FINAL PLAT

THE GATEWAY CENTER ADDITION

RE: S/D 99-2 -- Final Plat of THE GATEWAY CENTER ADDITION

STAFF REPORT

FINAL PLAT
THE GATEWAY CENTER ADDITION
 AN ADDITION TO WICHITA, SEDGWICK COUNTY, KANSAS

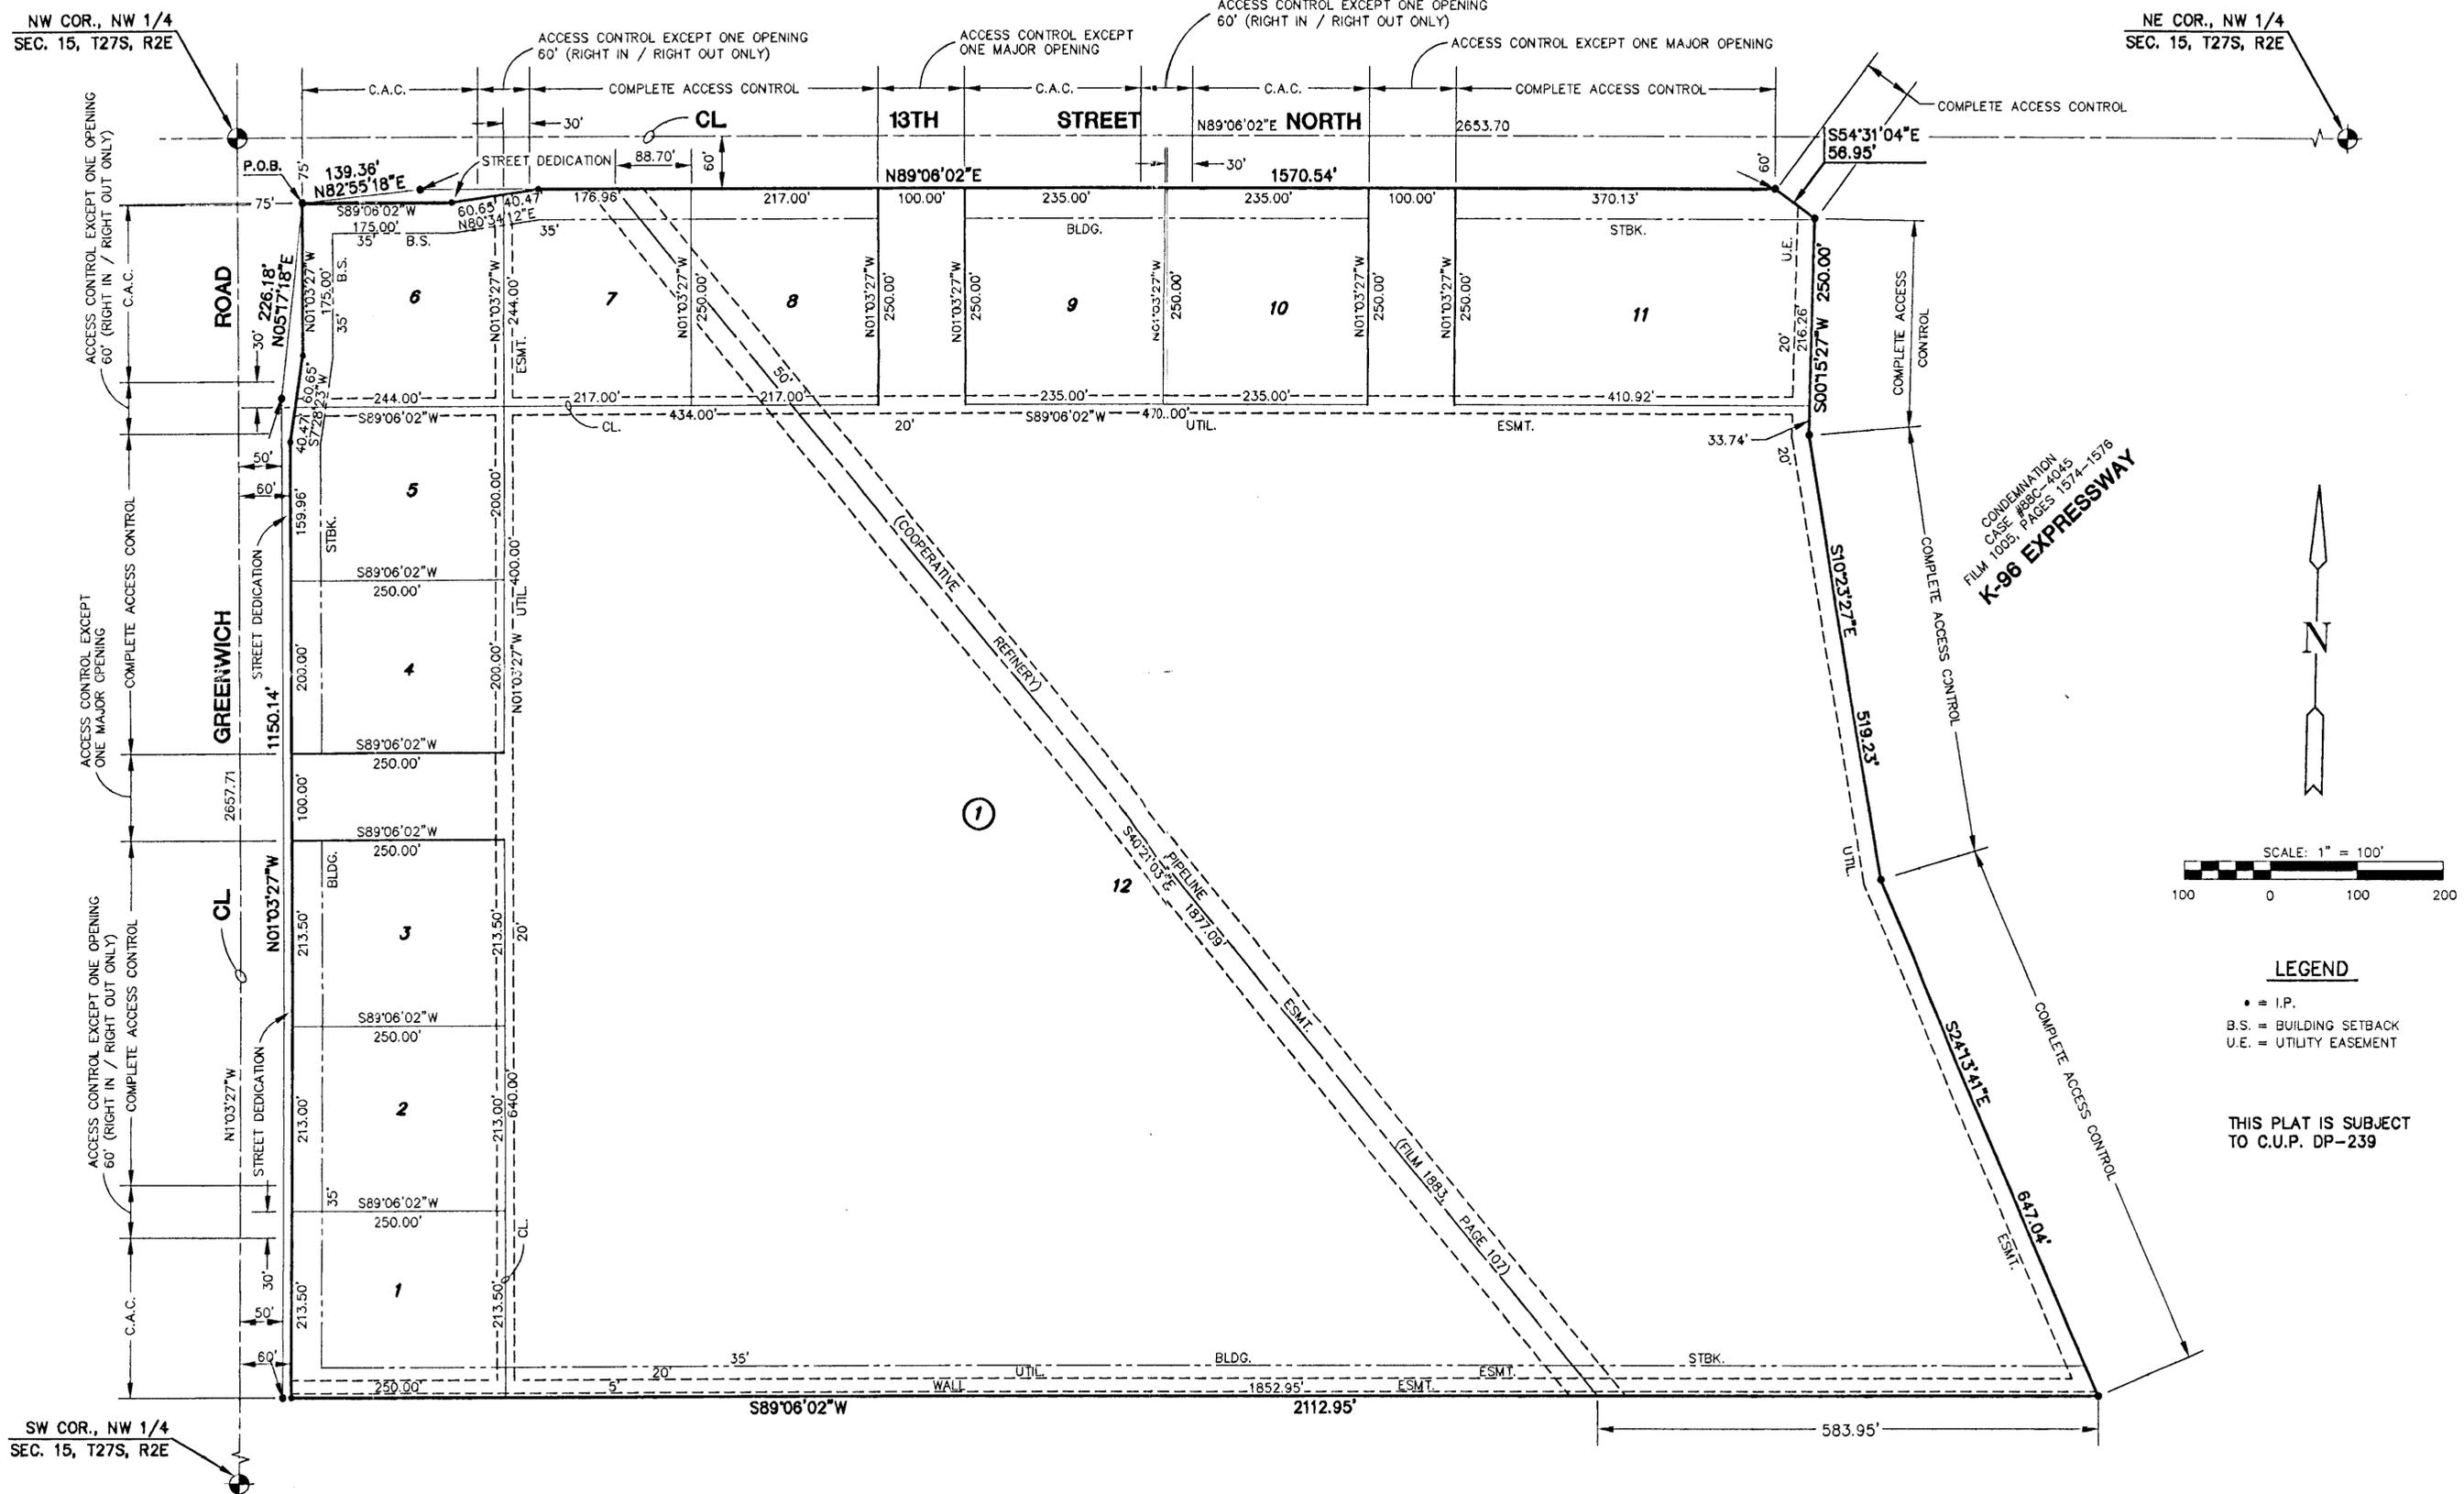
- A. As this site is adjacent to Wichita's City limits, the applicant shall submit a request for annexation. If the applicant desires to complete the plat prior to annexation, both the City and County signature blocks need to be included on the final plat.

- B. This plat will be subject to approval of the associated zone change (SCZ-0783) and CUP (DP-239) and any related conditions.
- C. This site is located in the County's Four Mile Creek sewer system and will be served by the County. County Engineering requires the submission of an off-site sanitary sewer easement.

- D. The applicant shall guarantee the extension of City water to serve the lots being platted.
- E. City/County Engineering needs to verify if any other guarantees or easements are required.

- G. City Engineering needs to comment on the status of the applicant's drainage plan. An off-site drainage easement is required. A guarantee is required for drainage improvements.

- H. The plat denotes five access openings to Greenwich Road and seven access openings along 13th St. North. The Subdivision regulations encourage shared access points for multiple lot commercial subdivisions along arterials.

Traffic Engineering needs to comment on the acceptability of the access controls. Any joint access easement shall be established by separate instrument. Distances should be shown for all segments of access control. Traffic Engineering has approved three openings from the property to Greenwich and four openings to 13th St. North. On Greenwich, the northernmost of the three openings is limited to right turns in and out. A joint access between lots 1 and 2, a major opening between lots 3 and 4, and a joint access between lots 5 and 6 are approved along Greenwich. On 13th St. North, two of the four permitted openings will be major openings (one shall align with Chapel Hill Road and the other shall align with the entrance to Dillons north of 13th Street North) with left and right turns, and the other two openings shall be limited to right turns in and out (one shall be a joint access opening between Lots 6 and 7 and the other shall be located between lots 9 and 10).

- I. The applicant shall submit a copy of the instrument which establishes the pipeline easement on the property, which verifies that the easement shown is sufficient and that utilities may be located adjacent to and within the easement. The final plat tracing shall also indicate the recording information for the pipeline easement.

- J. The applicant's agent shall determine any setback requirements for the pipelines by researching the text of the pipeline agreements. If a setback from the pipeline easements is provided for in the pipeline easement agreements, it shall be indicated on the face of the plat and further noted that the setback is a building setback line for the Farmland Industries pipeline.

- K. Traffic Engineering needs to comment on the need for any improvements to perimeter streets. In accordance with the zone change (SCZ-0783) and CUP (DP-239) Traffic Engineering has required the following: Along 13th Street North a continuous eastbound accel/decel lane shall be guaranteed from Greenwich to the K-96 on-ramp; plus a center median with two openings, one at Chapel Hill Road and the other to line up with the entrance to Dillons north of 13th St. North; if no median is constructed, the two minor openings shall be designed with raised diverter medians to only permit right-turn movements; and the applicant shall guarantee a portion of the cost of signalization at the intersection of 13th St. North and one of the major openings.

Along Greenwich Road, the Applicant shall guarantee a temporary left turn southbound lane as long as Greenwich remains a two lane road. The Applicant shall guarantee a permanent southbound left turn lane to the major opening when Greenwich becomes a four-lane road.

- L. A CUP Certificate shall be submitted for recording with the Register of Deeds prior to City Council consideration, identifying the approved CUP and its special conditions for development on this property.
- M. The final plat shall indicate that the Addition is subject to the conditions of the associated CUP.
- N. The name of all owners who are signatories on this plat must be printed beneath their signature.
- O. The applicant shall install or guarantee the installation of all utilities and facilities which are applicable and described in Article 8 of the MAPC Subdivision Regulations. (Water service and fire hydrants required by Article 8 for fire protection shall be as per the direction and approval of the Chief of the Fire Department.)
